CALGARY PLANNING COMMISSION

October 7, 2021, 1:00 PM IN THE COUNCIL CHAMBER

Planning & Development Report to Calgary Planning Commission 2021 October 7

Policy Amendment to the Eau Claire Area Redevelopment Plan (Ward 7), LOC2021-0132

Massing relationship to context, distribution on site, and orientation to street edges
Shade impact on public realm and adjacent sites

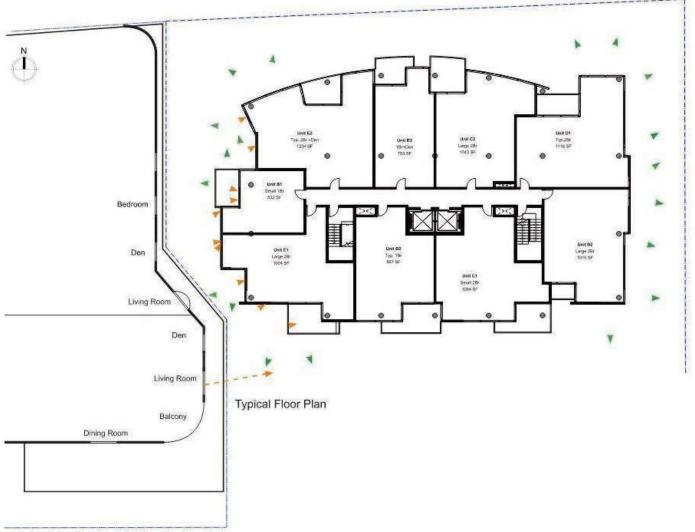
The building extends almost to the site edges at the West/East, optically crowding the existing neighbouring buildings. The resolution of the side elevations with respect to views, windows, etc should be further studied by the Applicant. The building setback and associated plaza facing 2nd Avenue seemed reasonable with the improved landscape design. Details showing how the 'pocket park' might be used by the public (seating for example) would be important to develop.

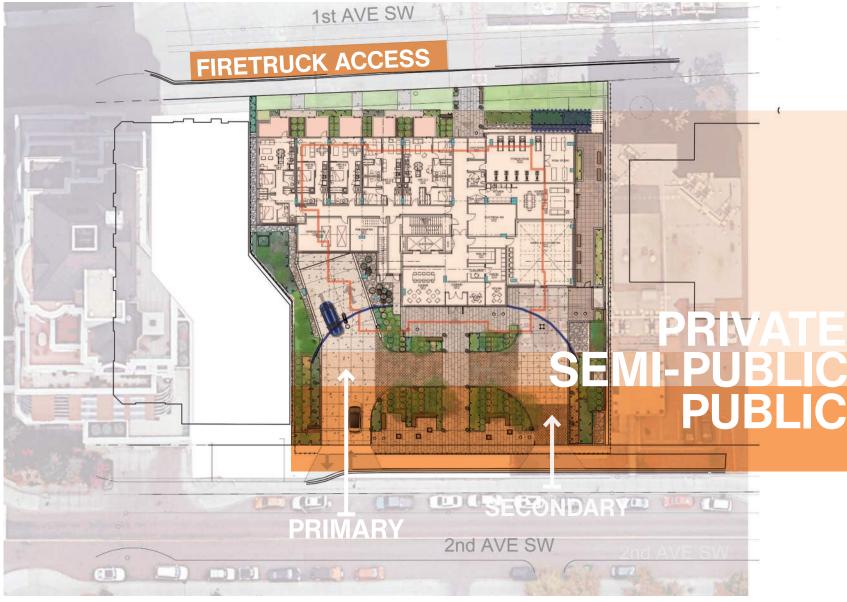
The project is set back significantly from 2nd Ave SW, making this a very 'private' building, not particularly well integrated into the community. Front plaza is suitably landscaped, however vehicular traffic is present in the plaza, including waste & recycling service driving through this area. Option for fire truck access off 1 Ave SW should be reviewed. Townhouse units off 1 Ave SW appear to have a stronger integration however 2-storey units may further improve overall massing of the tower.

The 2nd Avenue design aims to reinforce and provide private indoor, private outdoor and public outdoor spaces delineating the uses and access into the site. We have developed an architecture which emphasizes the public feature through a defining 1 ½ storey curved screen. This screen provides a transition to adjacent buildings 2 storey blank base while subtly concealing the driveway and loading areas. The lobby and entry are designed with large glazing areas and defining round columns which extend two storeys.

The front plaza, landscaping is developed to reduce the impact of the service driveway for the waste and recycling and loading uses. On the other hand more attention is given to the main entrance on the north to increase the impact. We have emphasized the ceremonial aspect of address and entry by designing a front long canopy covering the main entrance which notionally extends out towards the sidewalk.

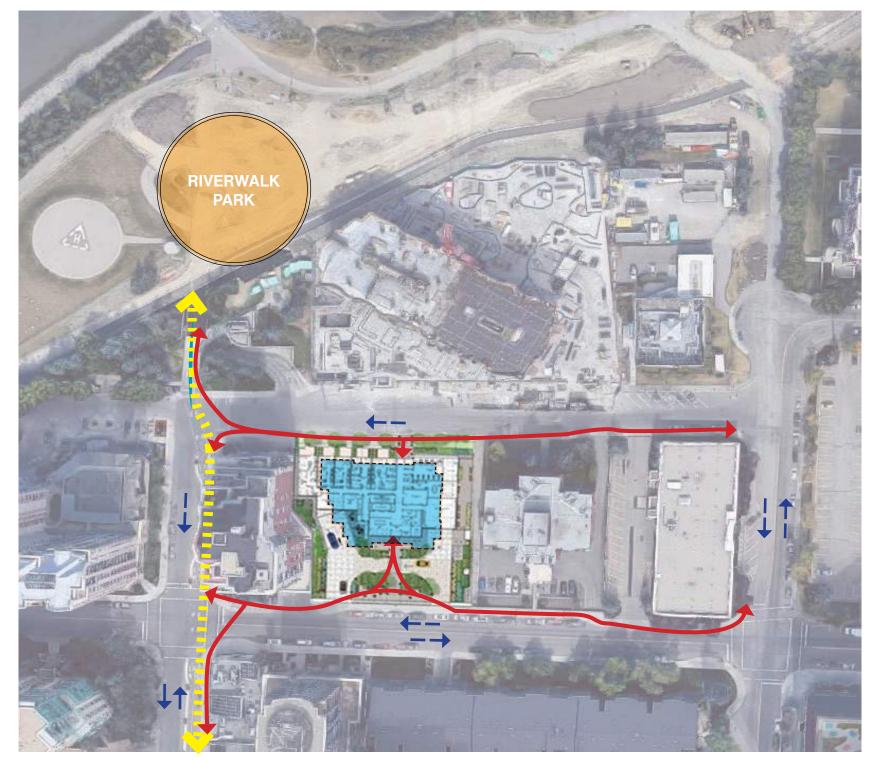
UDRP Commentary | Except for the front landscaped plaza and vehicle area, the connection to the public appears relatively weak in the proposed design. No through-site access provided, and fencing allows tenant access only. Applicant to review ground plane for improved connectivity; this may provide opportunity for site permeability of pedestrian travel. Vehicular connection to 2nd Ave SW rather than 1st Ave SW is supported

This project is a private property. For security and CEPTD reasons, promotion of public access use on or through the site is discouraged.

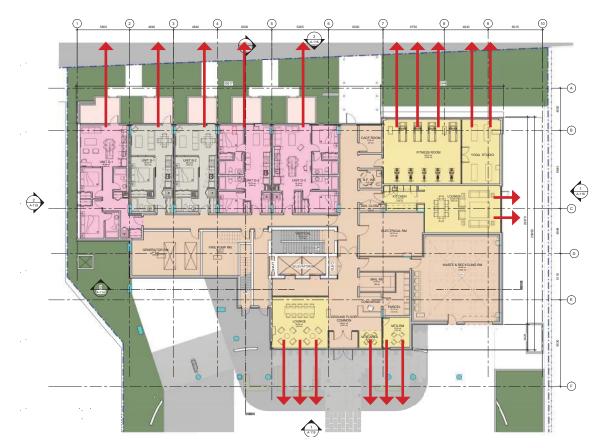
Strong use of front canopy and animation of front plaza landscape. Note that the project depends primarily on lighting, fencing, and proposed electronic surveillance to achieve security objectives rather than 'eyes on the street' except for the townhouse units along 1st Ave.

The active lobby space with full glass walls allows visual transparency and connection with the exterior. The presence of the concierge in lobby, balconies on both north and south of the building, amenity and the townhouses in the north, patio and the café (Social Spaces) in the front, all provide visual connections and "eye on the street" security for the residence.

Rows of trees in the east and west side of the central plaza create a sense of space and safety. Also raised planting are placed along edges to screen adjacent walls and frame building's architecture. All areas at grade are utilized to avoid hidden spots and corner for safety and comfort of the residents and public.
